PIC18F2455/2550/4455/4550

PIC18F2455/2550/4455/4550 Rev. A3 Silicon Errata

The PIC18F2455/2550/4455/4550 parts you have received conform functionally to the Device Data Sheet (DS39632C), except for the anomalies described below. Any Data Sheet Clarification issues related to the PIC18F2455/2550/4455/4550 will be reported in a separate Data Sheet errata. Please check the Microchip web site for any existing issues.

FIGURE 1: SCK PULSE VARIATION USING TIMER2/2

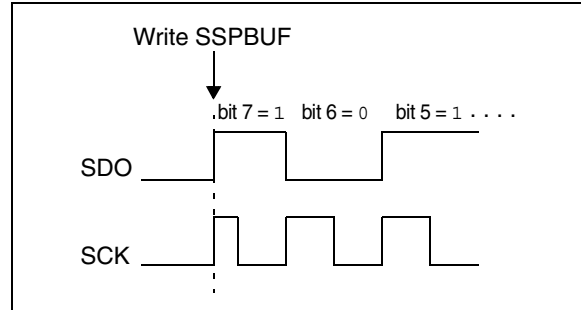
When the SPI is using Timer2/2 as the clock source, a shorter than expected SCK pulse may occur on the first bit of the transmitted/received data (Figure 1).

To avoid producing the short pulse, turn off Timer2 and clear the TMR2 register, load the SSPBUF with the data to transmit and then turn Timer2 back on. Refer to Example 6 for sample code.
